Landscape Comments

Issue date: 30.11.23

HPK/2022/0484 Chapel-en-le-Frith- luxury glamping pods

Below: Plan 5: Visual Appraisal (13616/P06b) extract from the LVA showing chosen viewpoints close to the site

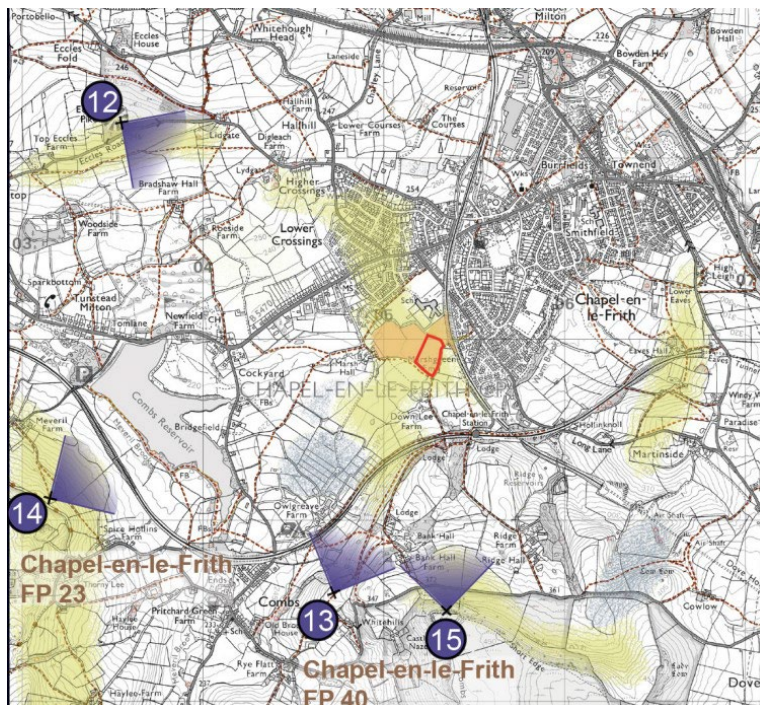
I also consider that Viewpoint 13 to the SW of the site is beyond the Visual Envelope and that there are other more representative viewpoints to explore the Visual Envelope extending to the south of the site such as the PRoWs to the south of the Buxton railway line one of which is illustrated below:

Above Viewpoint 15 – Coombes Moss (Castle Naze) within the PDNP

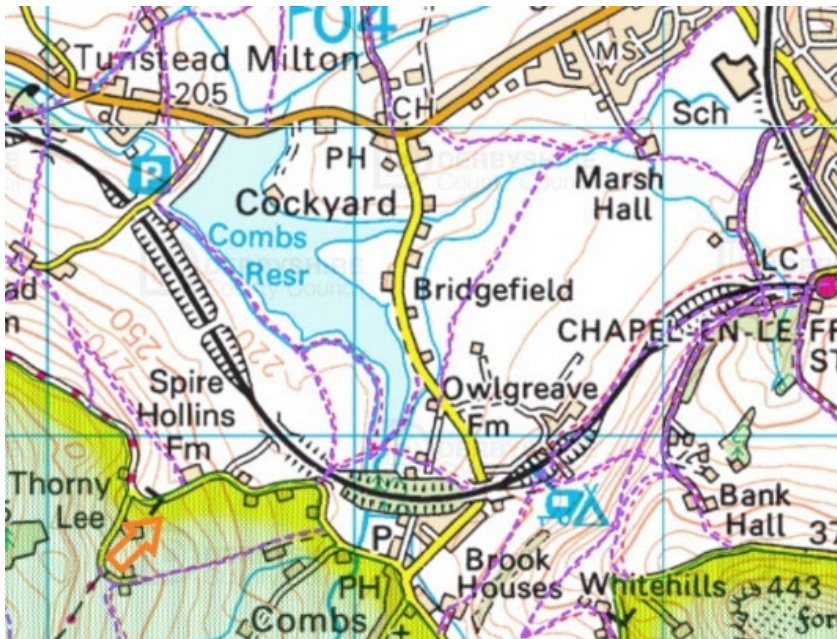
Above additional view from PRoW by Thorny Lee within the PDNP between viewpoint 14 and 15, in this view vegetation screens the urban edge near to the site and the site is clearly visible, the proposed glamping pods would appear as stand alone development detached from the urban area of Chapel-en-le-Frith.

Looking north from end of spur of high ground the site is in the natural direction of the view, although it is in the context of the urban area of Chapel-en-le-Frith the site is clearly visible and closer to the viewer than the urban area. I consider the photo view in the LVA is taken under conditions of poor light and that the site is more visible than suggested, therefore I would consider visual impacts to be as follows:

Sensitivity: High

Magnitude of change: Low

Nature of Effect: Adverse
